21081 Sunflower Consolidated SD Phase II / Report Number 004

Observations

Figure 2 – Masonry Mock up

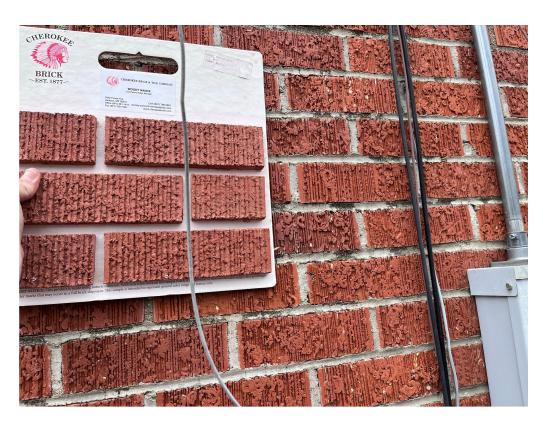
Preinstall meeting attendees. A mockup of CMU has been built and looks to be in good order. I compared masonry samples given to existing and

at Thomas Edwards, the matches look good.

Figure 19 – Brick too dark and needs more yellow

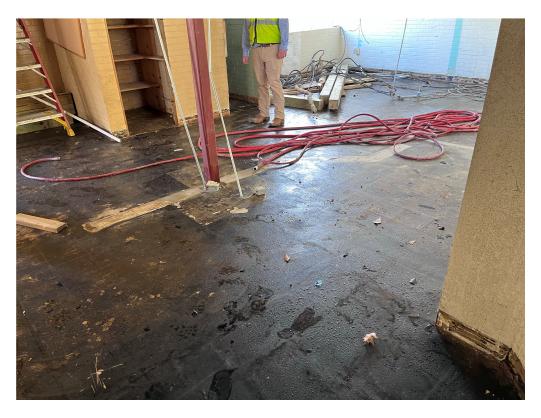
On site at Gentry, Trey Jacobs & Keith Graham walked the site with me. We discussed ceiling heights in the south west existing building to remain. We also discussed brick color and will need to work on the submitted brick sample. This sample matches the newer east buildings but does not match the cafeteria that we are tying into. The contractor will need to submit new samples to match better.
